1997 SEMINAR INFORMATION

"THE RIGHT DIRECTION FOR '97"

AUTOMATIC TRANSMISSION SERVICE GROUP
9200 S. DADELAND BLVD.
SUITE 720
MIAMI, FL 33156
(305) 670-4161

Figure 1

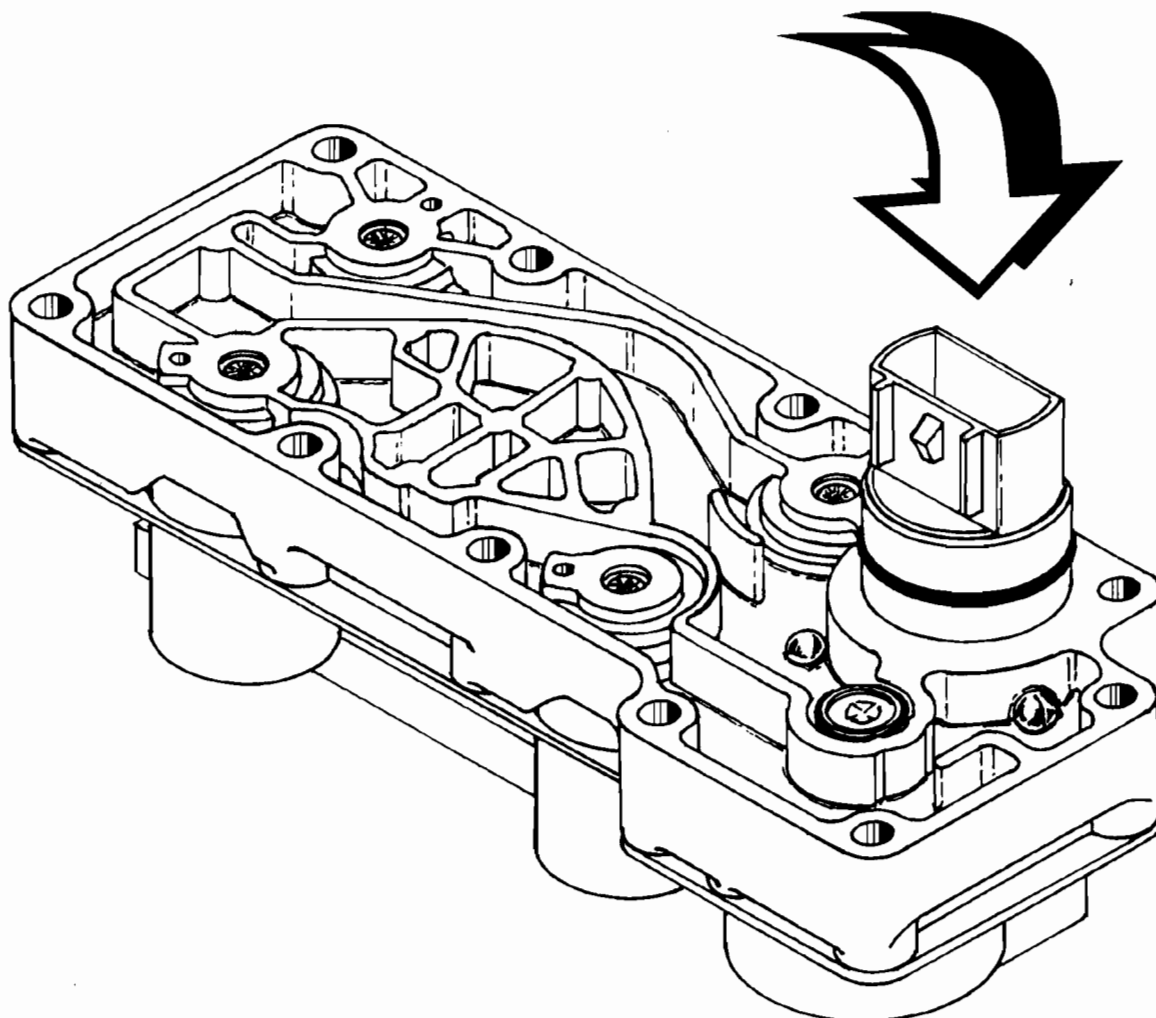
CHANGE: Beginning at the start of production for 1995, all models of the E4OD transmission were produced using a new design solenoid pack, that will not interchange with previous models.

- (1) **SOLENOID PACK** - New design solenoid assembly case connector to accommodate the new design vehicle harness connector. Refer to Figure 1 for identification of the previous design and the new design solenoid assemblies.

THERE IS NO SLEEVE ON 1995 SOLENOID PACK

Figure 2

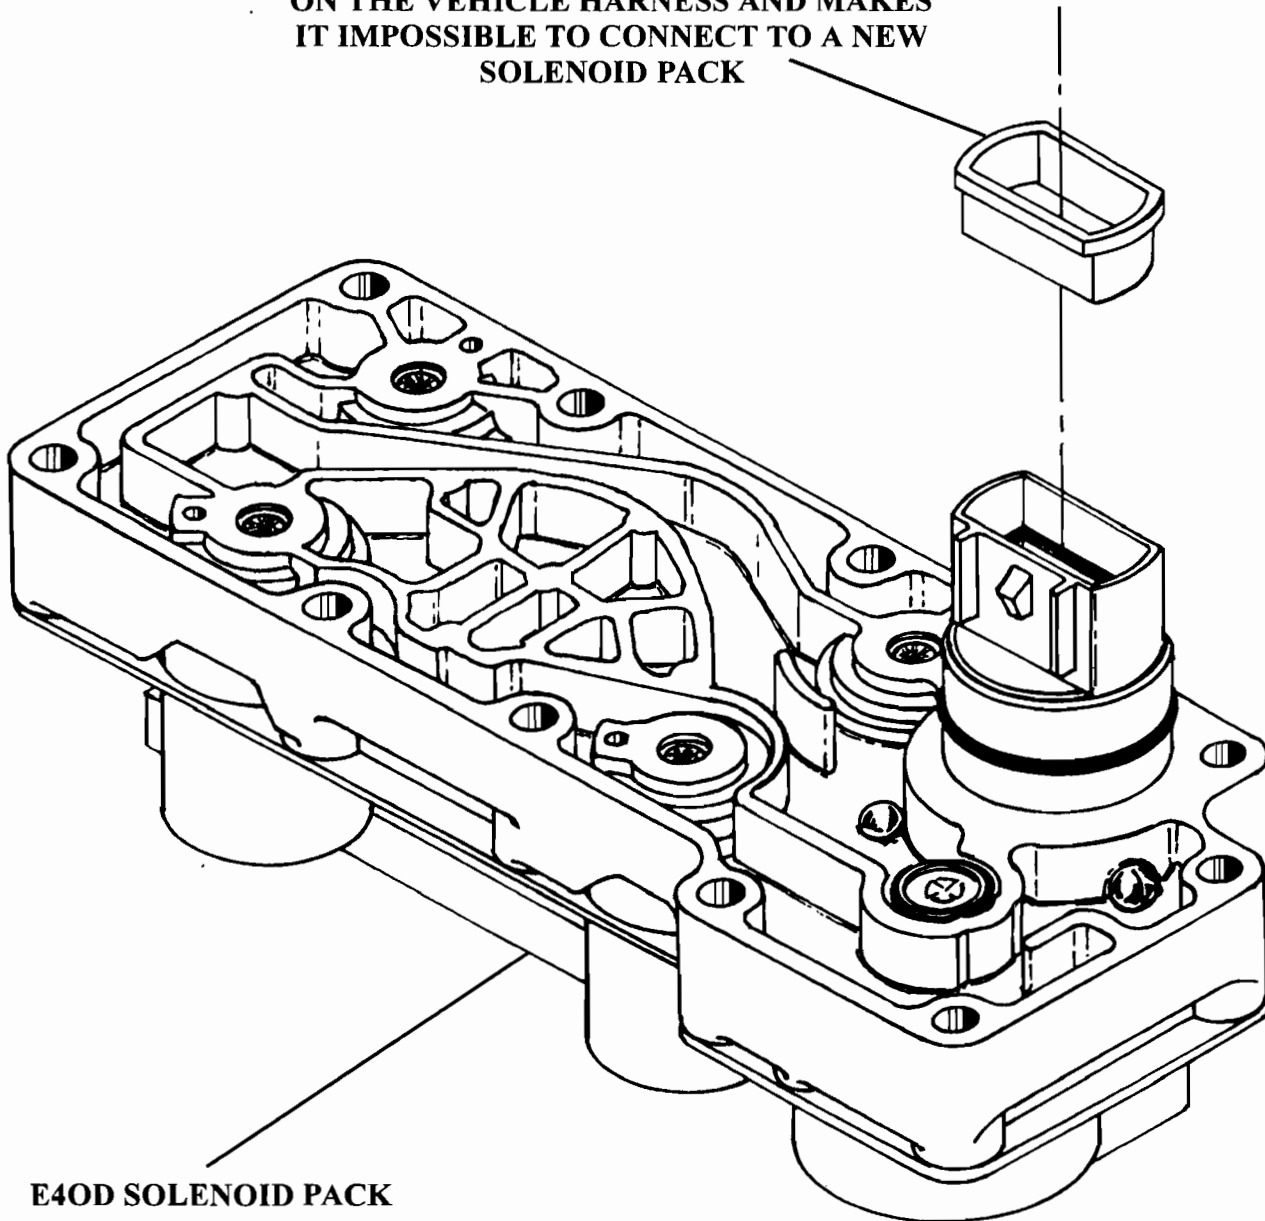
NOTE: The plastic sleeve incorporated in the previous design solenoid pack has been eliminated on the new design solenoid pack (See Figures 1 and 2). This plastic sleeve will sometimes remain on the vehicle harness connector when it is disconnected. If a new solenoid pack is installed (which includes sleeve), it will be impossible to reconnect the vehicle harness to the solenoid pack until the old sleeve is removed from vehicle harness connector. Refer to Figure 2.

**PLASTIC SLEEVE SOMETIMES REMAINS
ON THE VEHICLE HARNESS AND MAKES
IT IMPOSSIBLE TO CONNECT TO A NEW
SOLENOID PACK**

Figure 3

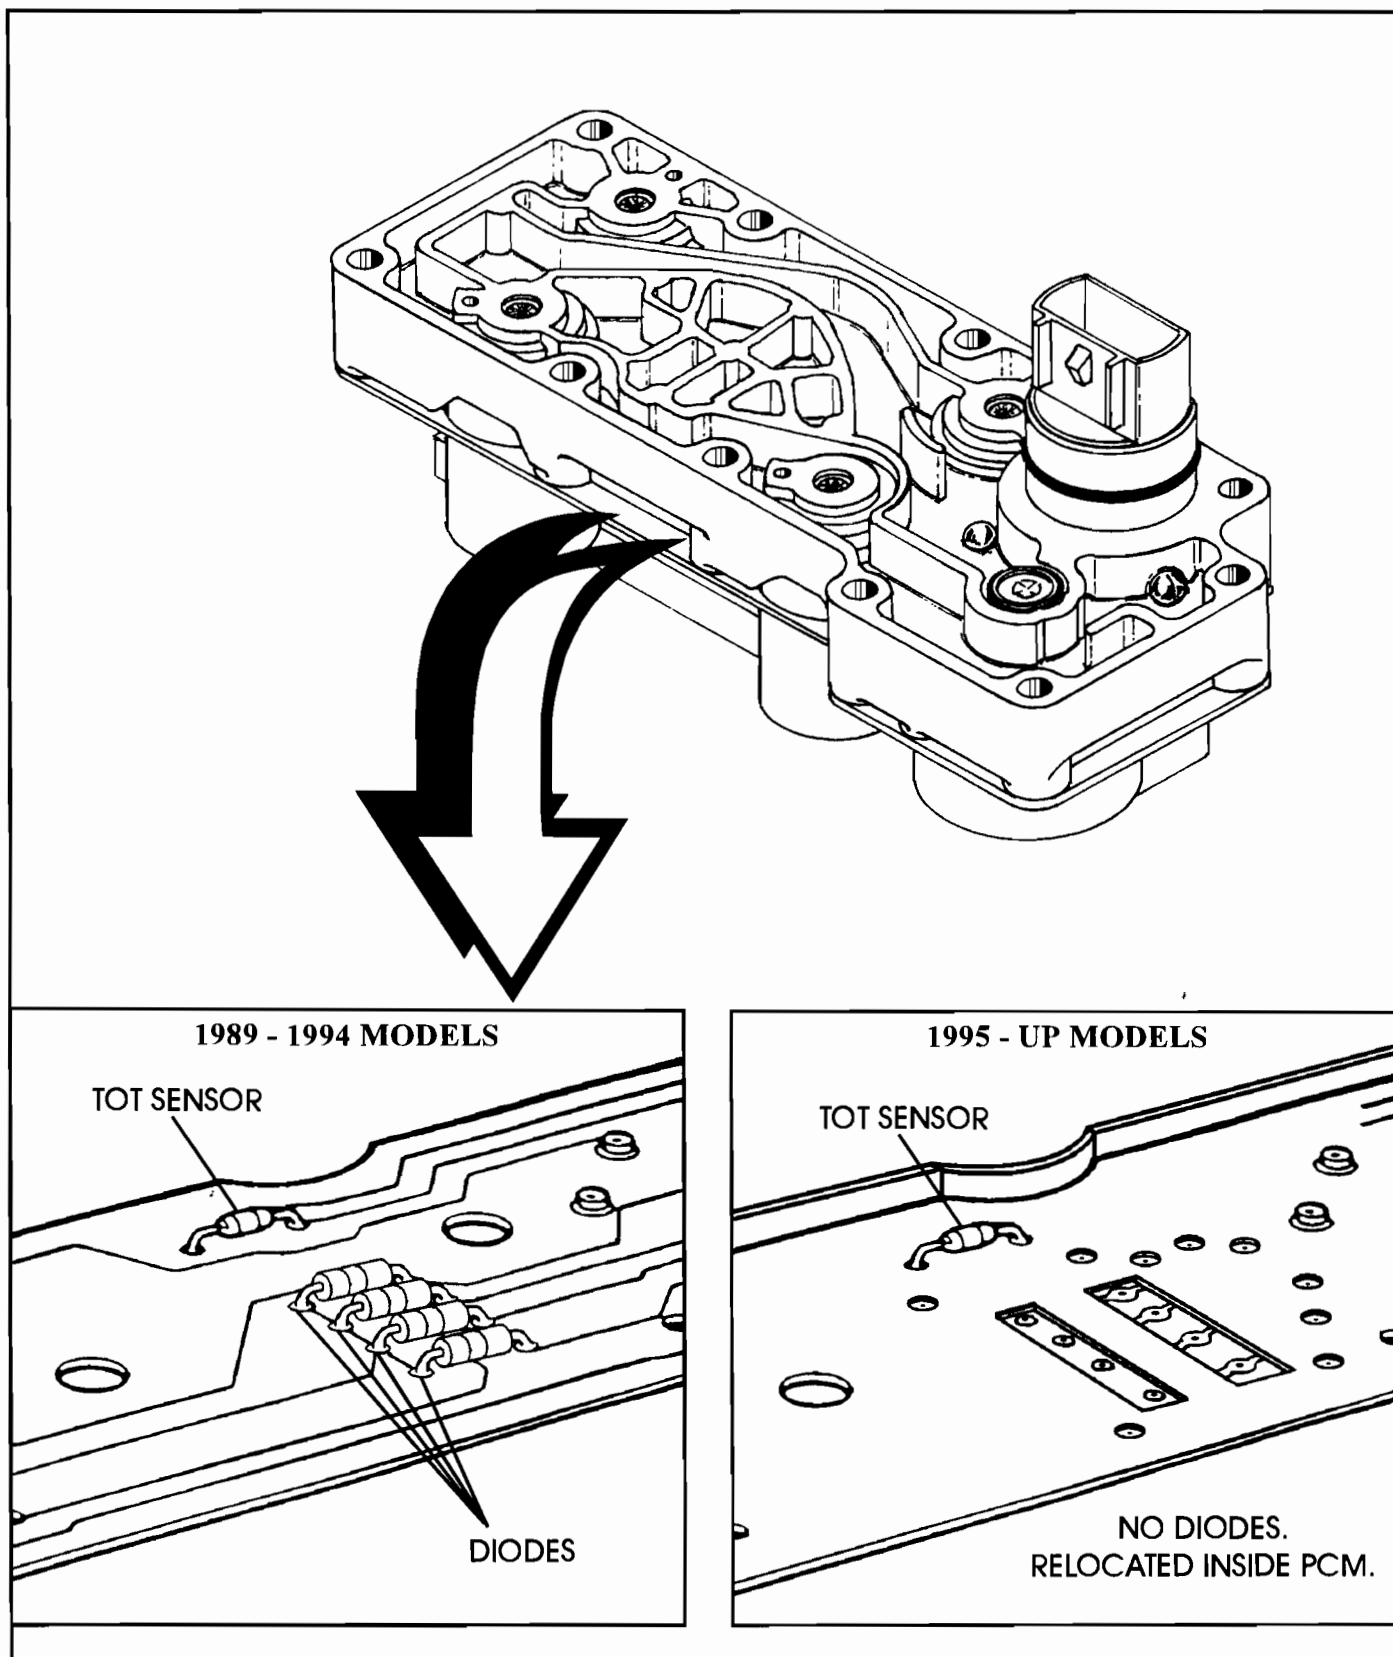
They will not interchange because in 1995 models the diodes for the solenoids were moved out of the solenoid pack and placed into the PCM (See Figure 3).

**1989-1994 PUMP BODY AND GEARS
ROUGH FORGING NO. E9TP-7A105-BA
(PREVIOUS DESIGN)**

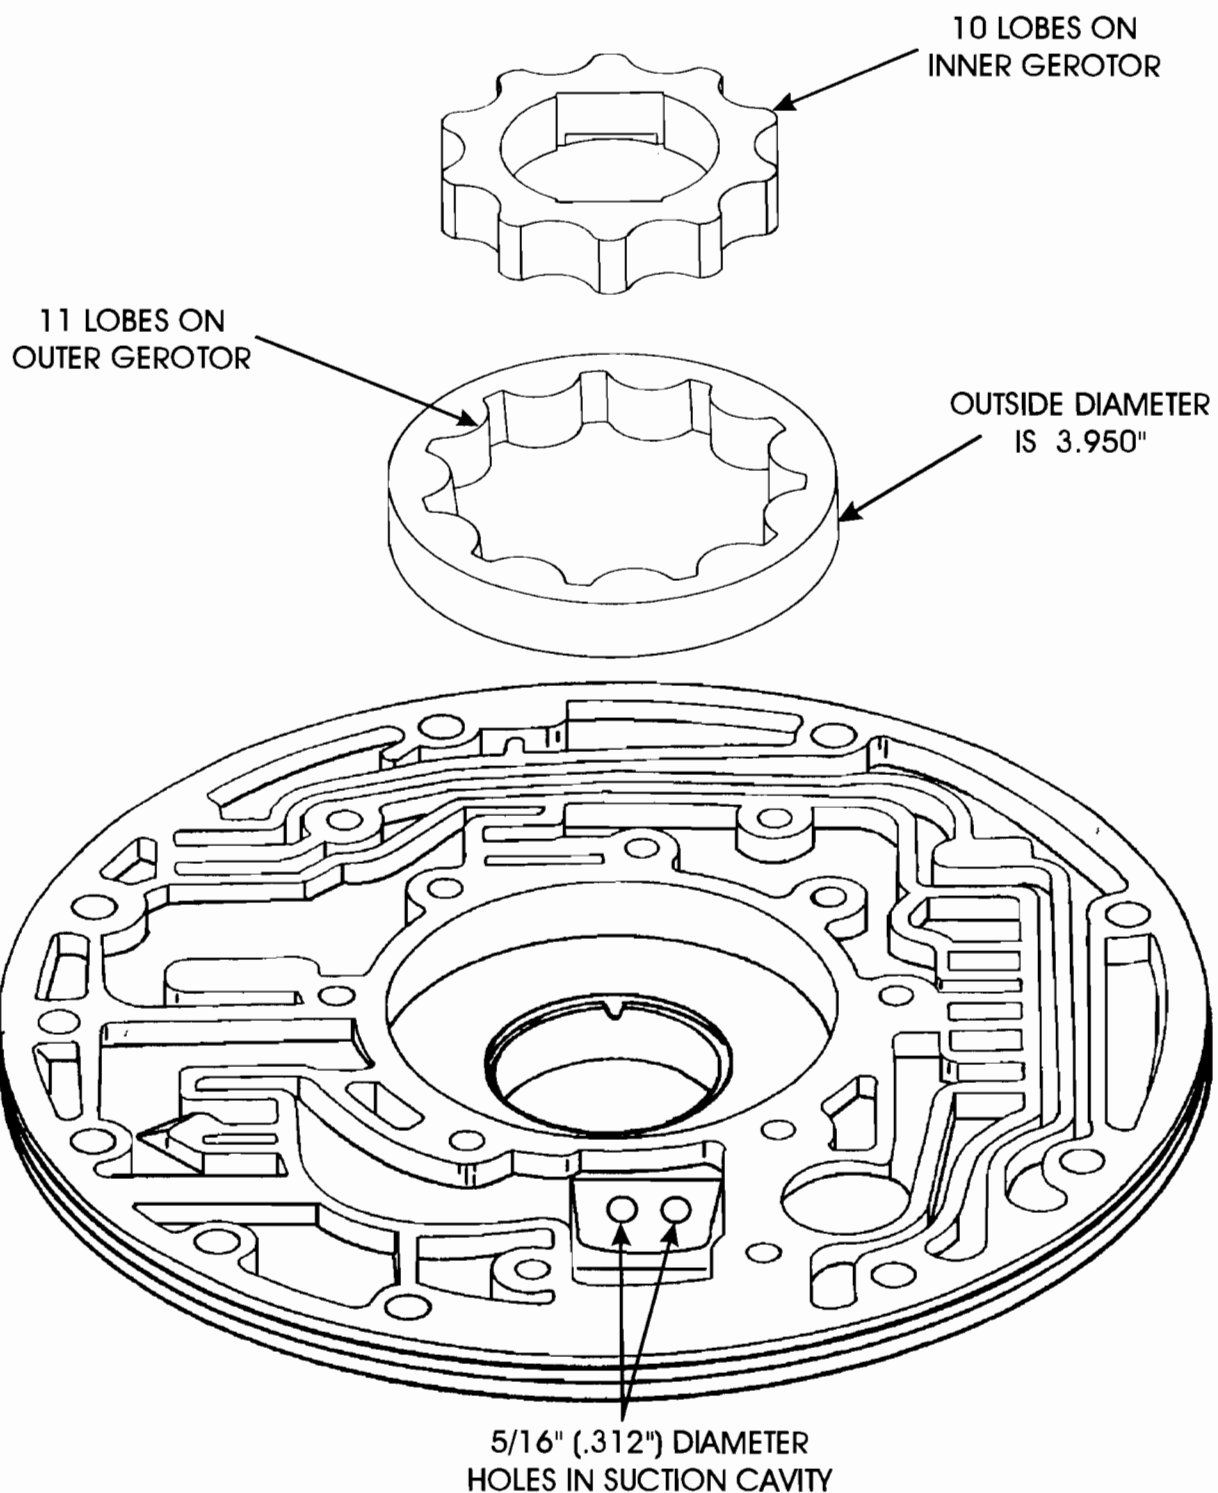
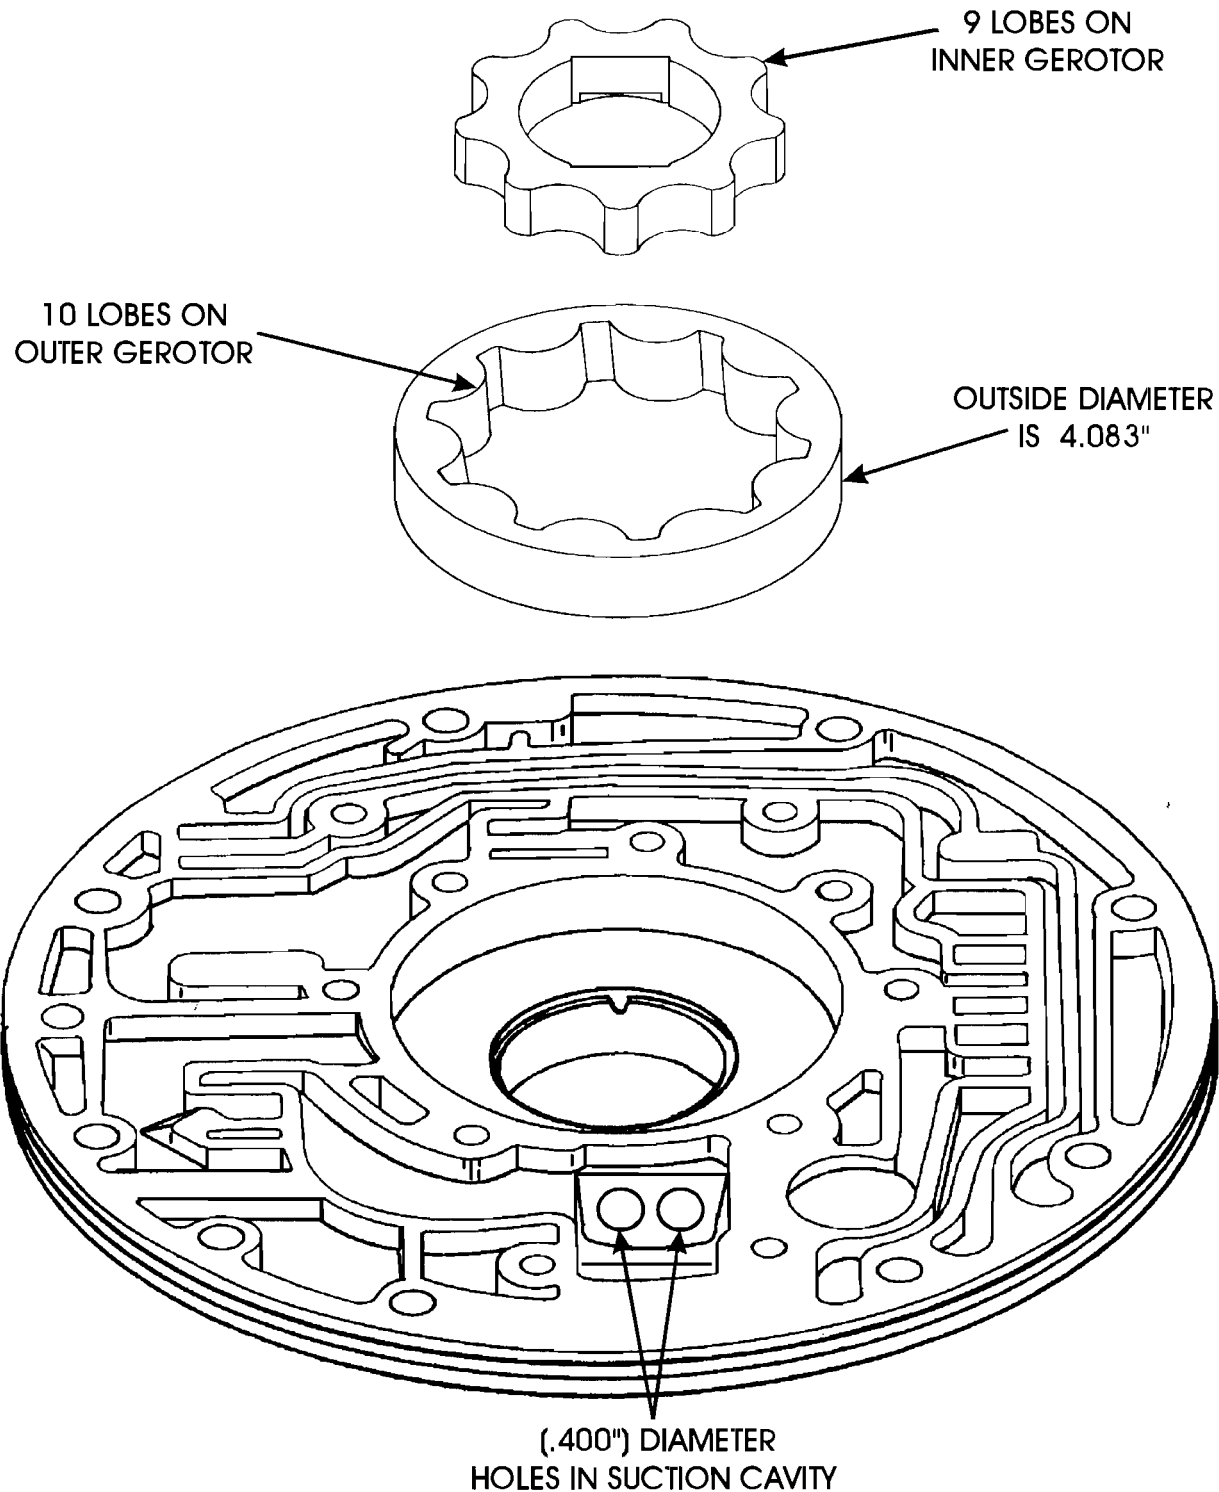
CHANGE: Beginning at the Start Of Production for all 1995 model E4OD transmissions, Ford Motor Co. introduced an increased displacement Front Pump Assembly, 1.70 cu in/rev, versus 1.50 cu in/rev for previous models.

REASON: To provide additional flow for more robust converter clutch functions and additional lube flow, both of which will greatly increase transmission durability.

- (2) **OUTER GEROTOR** - The lobes on the Outer Gerotor changed from the previous 11 lobes to 10 lobes on the new design, to accommodate the changes on the inner gerotor. The diameter of the Outer Gerotor also changed from 3.950" to 4.083". Refer to Figures 1 and 2. The changes on both the inner and outer gerotor increased the cavity between the gerotors for increased pump volume, as shown in Figure 3.

- (3) **INNER GEROTOR** - The lobes on the Inner Gerotor changed from the previous 10 lobes to 9 lobes on the new design, to accommodate the changes on the outer gerotor. Refer to Figures 1 and 2. The changes on both the inner and outer gerotor increased the cavity between the gerotors for increased pump volume, as shown in Figure 3.

Front Pump Assembly (New 1995 Design) F5TZ-7A103-A
